# SERVICE

NUMBER 72

**SUBJECT:** Rudder Pedal and Floorboard Attachment Lugs

**MODELS AFFECTED:** J3 and J5 Series

FLOORBOARD FITTING REPAIR

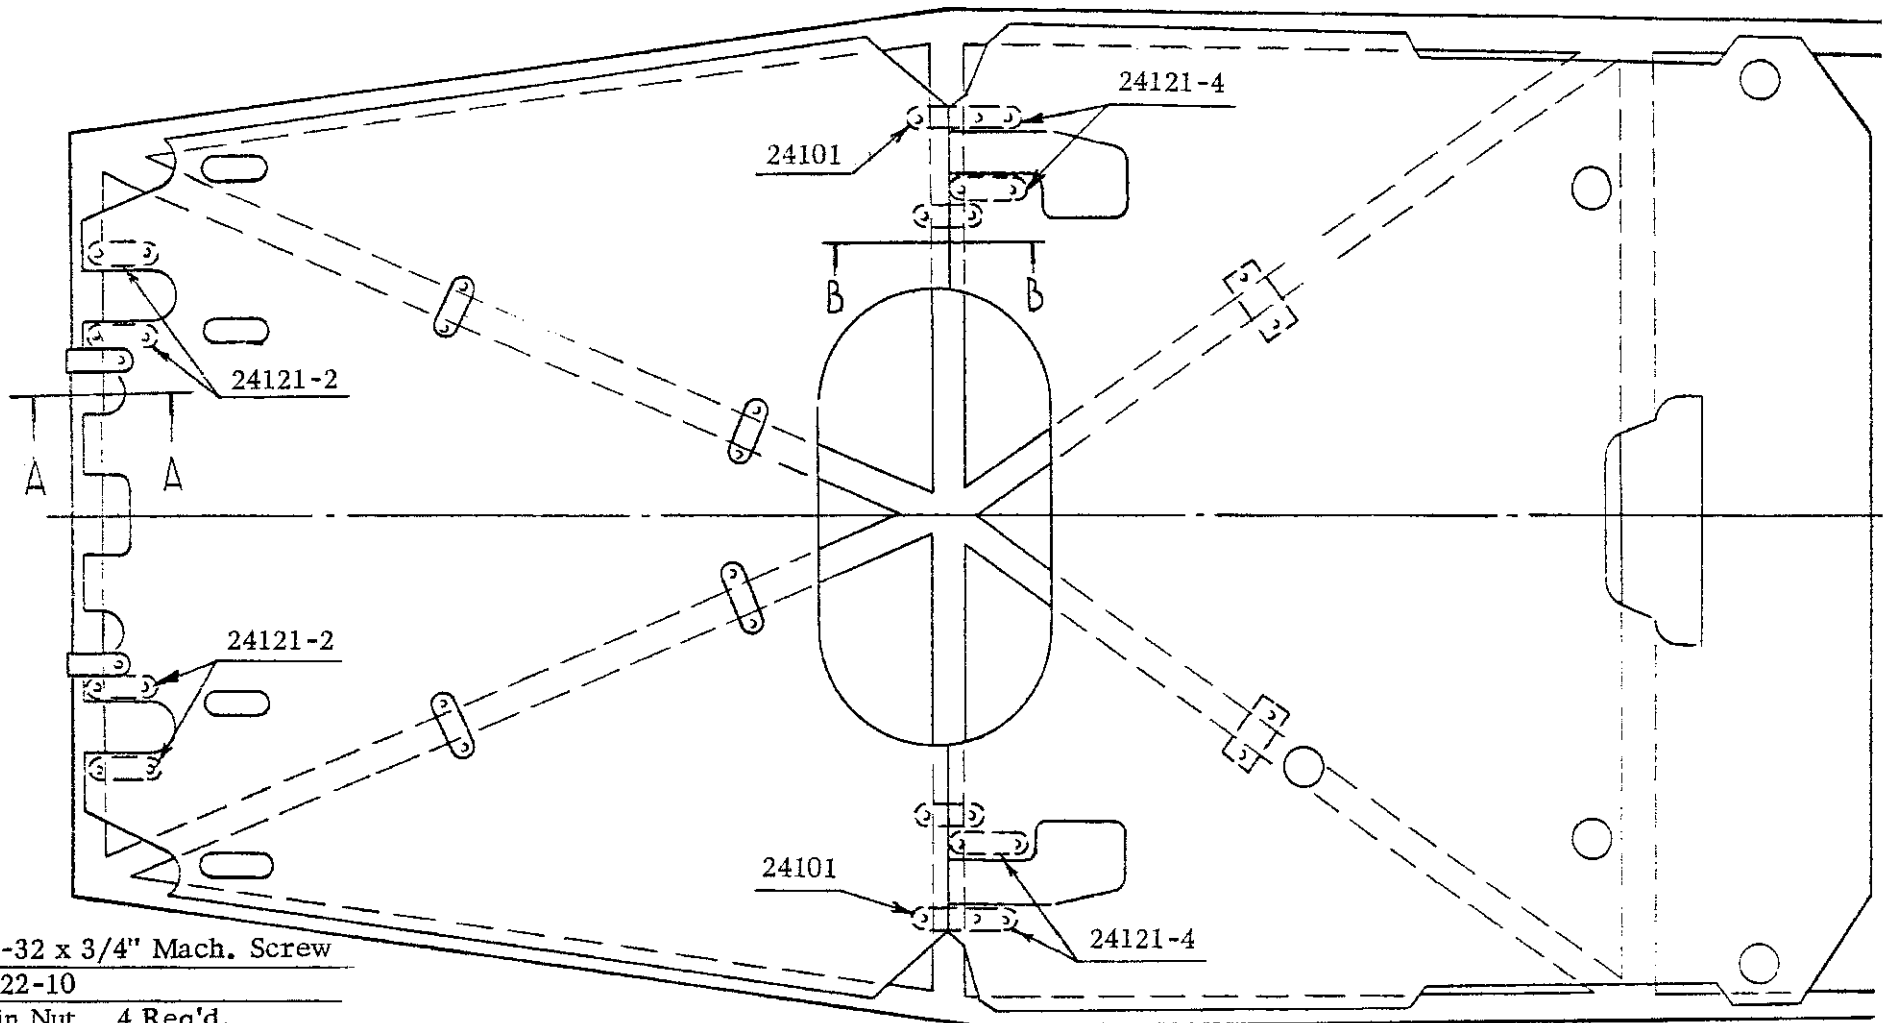
In the event that such failures are discovered, a temporary repair may be effected by attaching the floorboard with a clamp fastened about the tubular structure immediately adjacent to the failed part. (See attached sketches.) SAE No. 1025 steel strip .045" thick by 3/4" wide is recommended for such clamps. The original fittings should then be re-welded or replaced when convenient; in which case the repair clamps may be reinstalled for additional strength.

#10-32 x 3/4 Mach. Screw  
 80122-11  
 Plain Nut 14 Req'd.
